Product Change Notification

Product Change Notification: P-21-021196

General Product Description:

Terminal

I. Paper reel

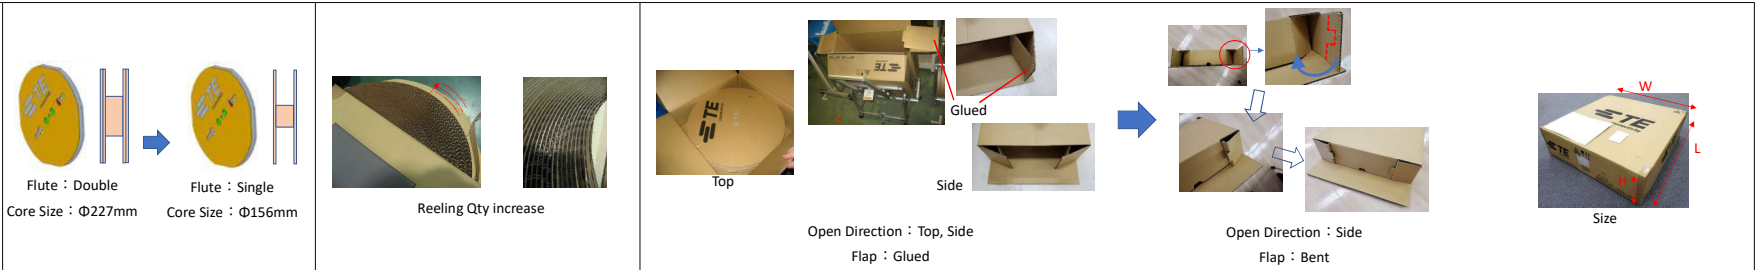
Standardization from double flute $\Phi 227\text{mm}$ core to single flute $\Phi 156\text{mm}$ core.
